CALIFORNIA COASTAL COMMISSION

STAFF REPORT: APPEAL SUBSTANTIAL ISSUE AND DE NOVO HEARING

Appeal Number A-3-PSB-99-026
Applicant Antone and Katherine Zaninovich
Appellants Commissioners Wan and Nava
Local Government City of Pismo Beach
Local Decision On February 9, 1999, the Planning Commission approved with conditions the demolition of an existing single family dwelling and the construction of a new single family dwelling on the same lot.
Project Location 307 Indio Drive, Pismo Beach, San Luis Obispo County (APN: 010-192-06)
Project Description 1) Demolition of a 2982 square foot single family residence located approximately eight to ten feet from the bluff edge of an ocean fronting lot and 2) the construction of a new 5169 square foot single family residence on the lot set back 29 feet from the bluff edge.
File Documents City of Pismo Beach Permit 98-120, City of Pismo Beach certified Local Coastal Program
Staff Recommendation Approval with Conditions

FIGURE 3
GEOLOGIC MAP OF BLUFF
ZANINOVICH RESIDENCE
307 INDIO DRIVE
PISMO BEACH, CALIFORNIA
SCALE: 1 INCH = 10 FEET

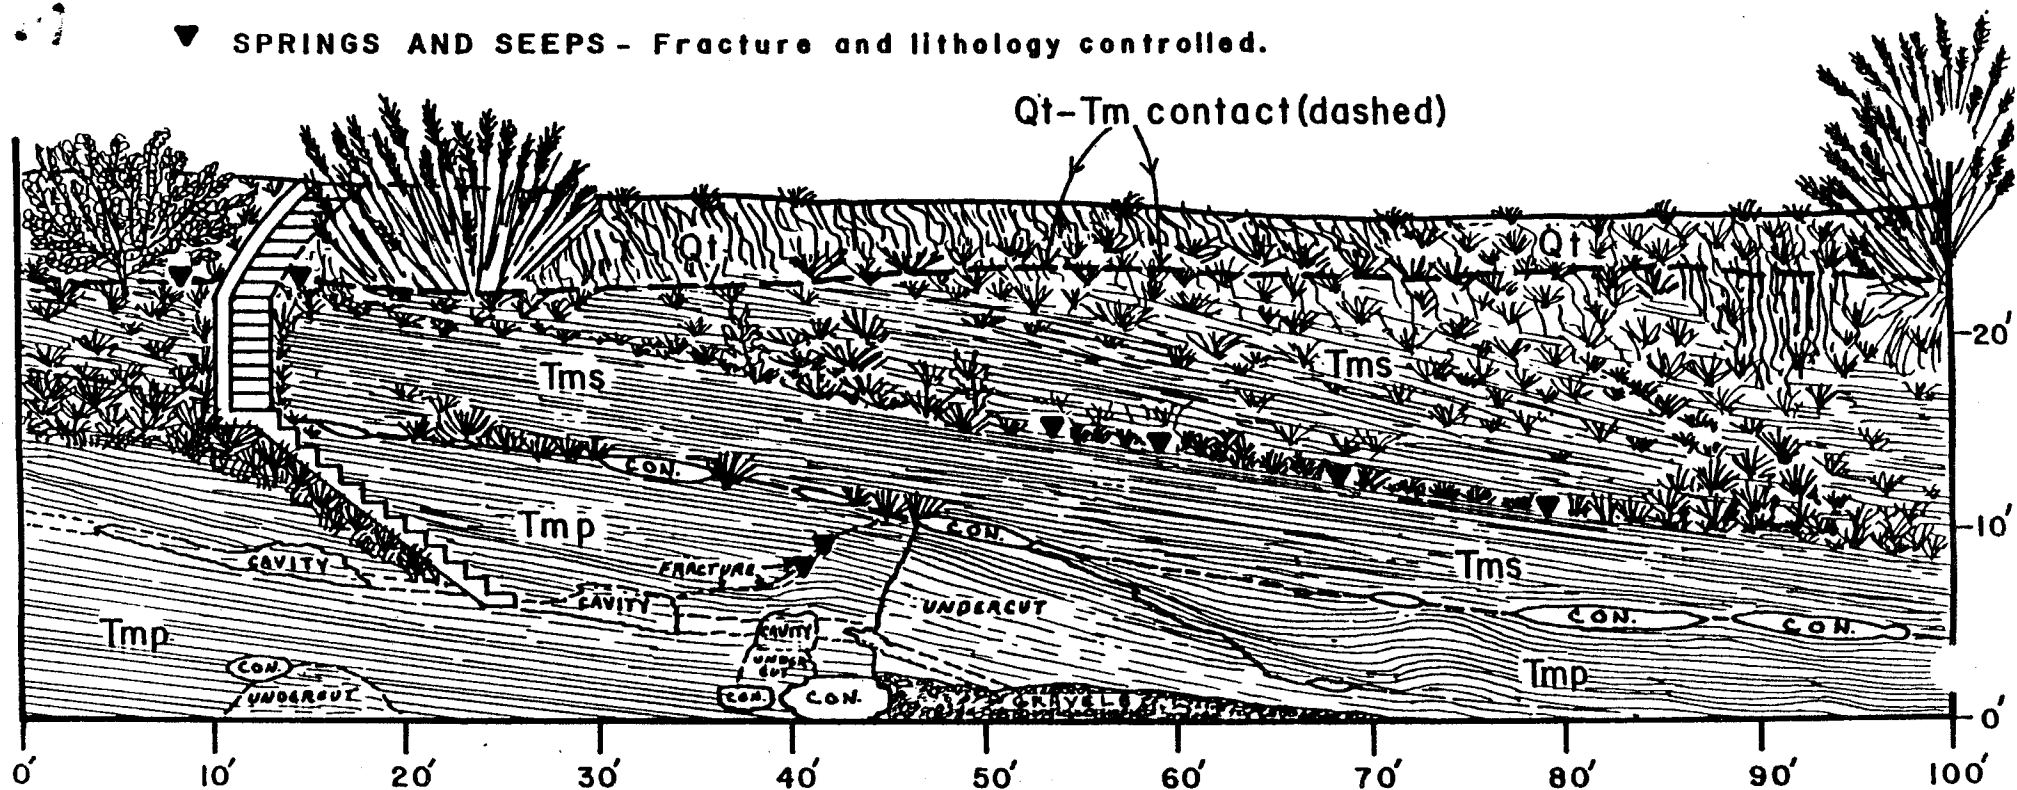
The Planning Commission required a setback of 29 feet across the entire width of the property. Based on a retreat rate of three inches per year, a 100 year setback would equal 25 feet. The Planning Commission's action apparently was based on the retreat rate of three inches as recommended in the geologist's addendum letter, rather than the four inches originally used, and was measured from the landward margin of the undercut portion of the bluff, approximately four feet landward of the bluff face.

The addendum letter states that the more liberal four inch per year rate reflects the erosional characteristics of the surface material, which is of minor thickness and apparently stable because it is vegetated and indicates that partly because of that and because the lower bluff materials are more erosion resistant, a retreat rate of only three inches is "a more applicable rate to establish the setback distance. However, it is this very surface material that would support the house and through which water, sewer, and gas lines would be placed. It seems imperative to establish an erosion rate based on this most erosion-prone material. Additionally, while the presence of vegetation may indicate that the terrace deposits are relatively stable, they are also relatively easily erodible.

In addition, as discussed in more detail in the de novo findings, there is a considerable uncertainty associated with the geological analyses in the vicinity of the project. Here, the geologic report established an overall average erosion rate of four inches per year based on the particular rates "of 6 to 12 inches per year. . .for the marine terrace deposits, and 4 inches for the shaley beds of the Monterey Formation." The addendum letter is not convincing in its attempt to establish a lesser overall estimated erosion rate, and it is not clear why the 4 inch per year rate, already a low estimate according to the original geologic report, should be further reduced. Thus, it is not clear that the "best case" assumption of a three inch per year erosion rate is appropriate. Moreover, even if this rate were correct, setting the new structure exactly on the projected 100 year erosion line does not necessarily guarantee structural stability for 100

years. Damage to structures typically occurs, and shoreline protection devices are typically approved, well before a bluff edge has retreated right up to a structure. Based on the original geological report and these other considerations, the City's action raises a substantial issue with the certified LCP. Policy S-3 states that the minimum setback for blufftop development is 25 feet but that "a greater setback may be applied as the geologic study would warrant." Section 17.078.050(1) similarly requires a minimum 25 foot setback but that "a greater setback may be applied if local conditions warrant." To be consistent with Policy S-3 and Section 17.078.050(1), the minimum required development setback with a 4 inch per year erosion rate is 33 feet ($100 \text{ years} \times .33 \text{ feet [4 inches]} = 33 \text{ feet}$), rather than 25 feet or 29 feet. The City-approved location of the house 29 feet from the current bluff edge at the estimated erosion rate would give the house only 88 years of protection ($29 \text{ feet} \div .33 = 87.8$). Thus, this action would also allow new development where a geologic projection indicates that shoreline protection may be necessary to protect the development in 88 years. In addition, there is no discussion of or permit condition prohibiting future shoreline protection or otherwise requiring use of non-shoreline structure alternatives for protecting the proposed house from future potential bluff erosion. This is inconsistent with the requirement of Section 17.078.060(5) that no new development be allowed where a geologic projection indicates that shoreline protection will be necessary within 100 years to protect the development.

PRIOR TO ISSUANCE OF THE COASTAL DEVELOPMENT PERMIT, permittee shall submit to the Executive Director for review and approval two copies of revised plans showing all proposed structures setback a minimum of 33 feet from the bluff edge or the landward extent of the undercut portion of the bluff, whichever is more landward, plus the buffer distance established by the supplemental geological report required by Special Condition No. 2 above.
